Delegated Report

Householder Planning Application

Planning Application No: 20240879

Description: Installation of a air source heat pump to front of property.

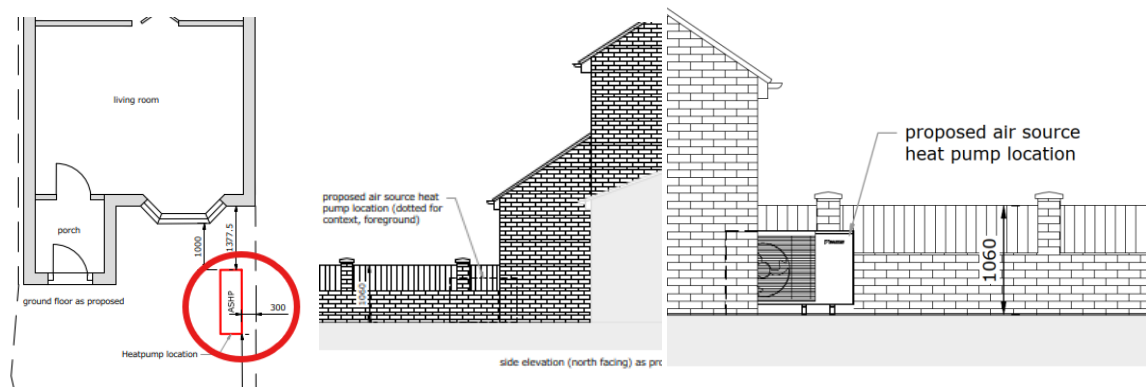
The MCS noise calculator shows that the noise level of the ASHP has failed. In addition, the calculator advises that the distance to the nearest receptor is 8m. Looking on google maps, the distance to the window above the garage of the adjoining house, which is likely to be a bedroom, is far less than this. This will result in an even higher outcome in terms of resultant noise level.

In this instance this threshold has been breached. If the equipment exceeds the 42dB it must be situated 8 meters away from the nearest receptor, however as can be seen from the above image and the comments from the environmental health team this is incorrect as there is a window situated above the neighbouring garage which likely serves a bedroom and so the impact of the unit in terms of noise would be harmful to the amenity of a neighbouring property.

Guidance advises that where an ASHP fails any of the criteria of an MCS assessment, that a BS4142:2014+A1:2019 assessment should be undertaken to ensure that does not exceed 35dB as far as is reasonably practicable (including penalties for noise characteristics such as tonal components) at 1m from the façade of noise sensitive and neighbouring residential premises. This is based on a LAeq measurement made over 15 minutes.

Therefore, this is required and should be undertaken and submitted for assessment prior to any determination of the application.

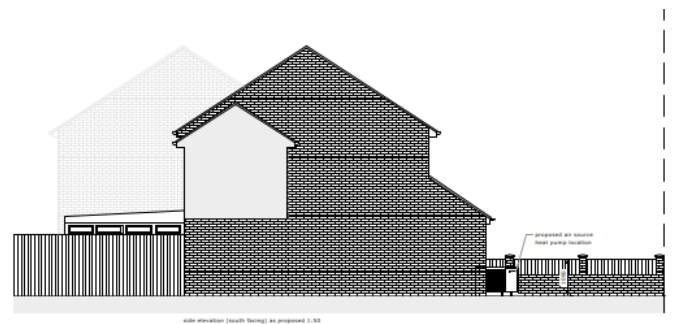
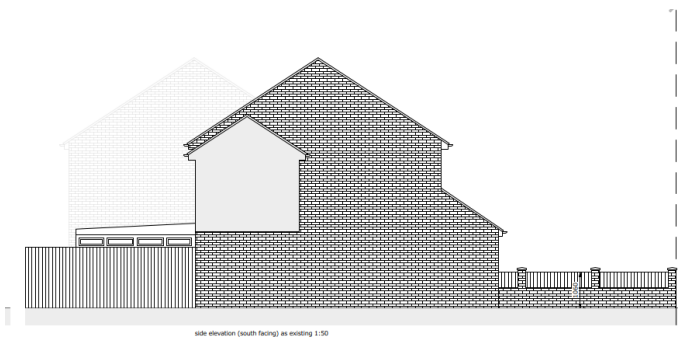
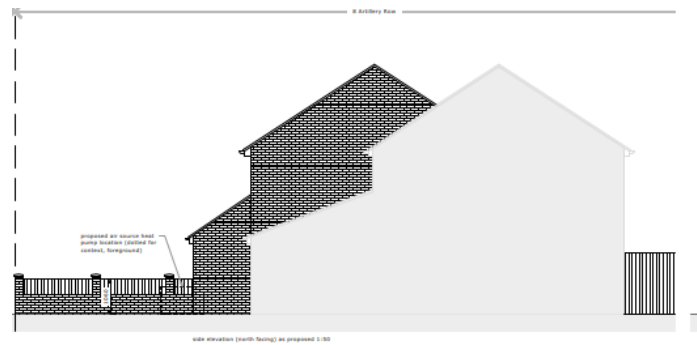
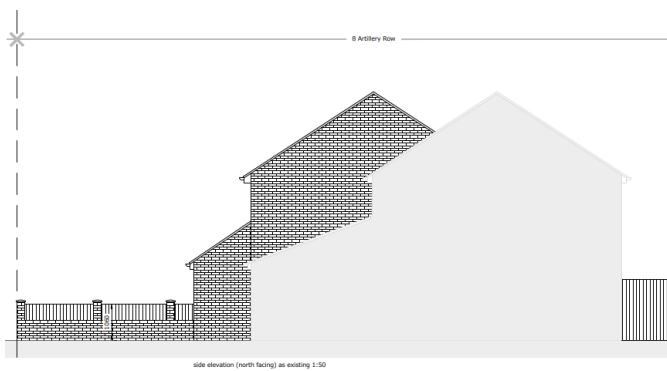
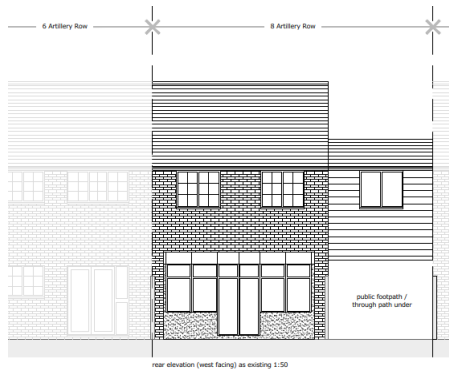
The proposed block plan shows the heat pump as being detached and situated away from the front elevation of the property, however the proposed elevations show the heat pump as being attached to the property.

Should permission be forthcoming then clarity will be sought regarding this matter.
